HISTORIC AND DESIGN REVIEW COMMISSION

Agenda Item No: 29

HDRC CASE NO: 2016-030
ADDRESS: 604 S ALAMO ST
LEGAL DESCRIPTION: NCB 13815 BLK 4 LOT 4
ZONING: O2 H
CITY COUNCIL DIST.: 1
DISTRICT: Lavaca Historic District
LANDMARK: Fire Station #07
APPLICANT: Joseph Smith
TYPE OF WORK: Rehabilitation and adaptive reuse
REQUEST:

The applicant is requesting a Certificate of Appropriateness for approval to perform various rehabilitative tasks and exterior modifications associated with the adaptive reuse of Fire Station Number 7 into a restaurant space.

03. FENCE DETAIL

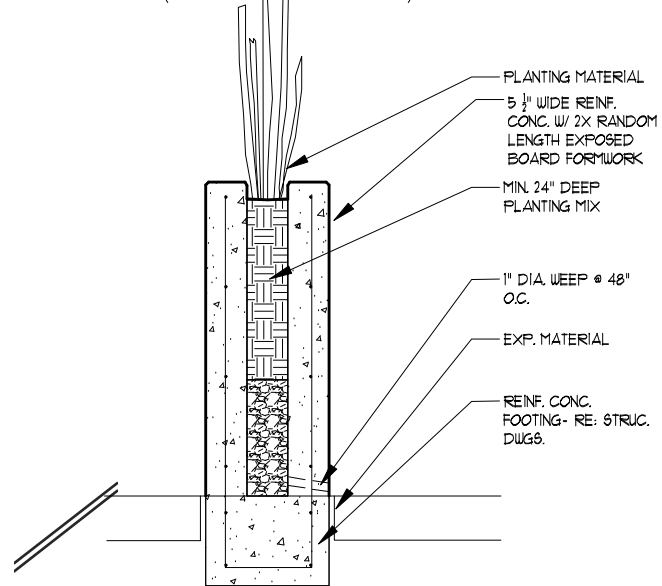
- i. Along the S Alamo property line, the applicant has proposed to install patio fencing. Staff finds the installation of fencing here to be appropriate provided fencing materials and height are consistent with the Guidelines for Site Elements. Staff recommends that the applicant provide information addressing these concerns to staff.

- i. That the applicant install wood doors comparable in design to the existing wood doors instead of aluminum doors as noted in findings f.
- ii. That the applicant provide additional information regarding the rooftop mechanical screen as noted in finding h.
- iii. That the applicant provide additional information regarding the proposed S Alamo fencing as noted in finding i.
- iv. ARCHAEOLOGY- An archaeological investigation may be required if the aforementioned stipulations are met.
- v. That the applicant provide information to staff regarding amended mullion thickness to be more consistent with a historic design and thickness. Staff recommends the approach that the applicant reconstruct wood doors consistent with what would have historically existed with pedestrian doors incorporated.

03. roof screen DETAILS (

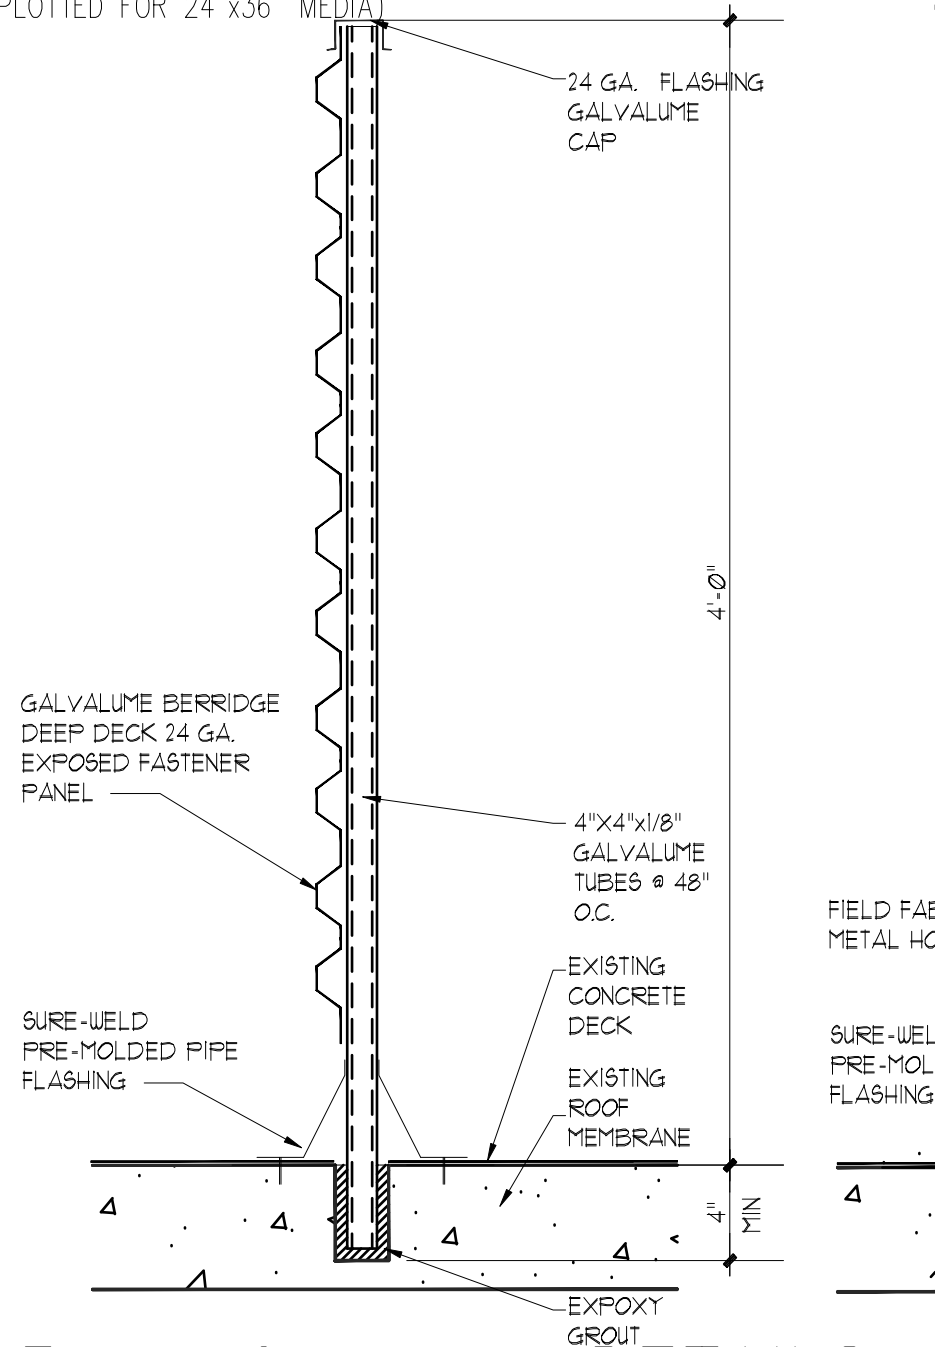
- h. At the rooftop level, the applicant has proposed to construct a roof screen, approximately three (3) feet in height to screen the installation of new rooftop mechanical equipment. While the applicant's proposal is consistent with the Guidelines regarding the screening of mechanical equipment, staff recommends the applicant provide additional information regarding materials, height and transparency of the screening.
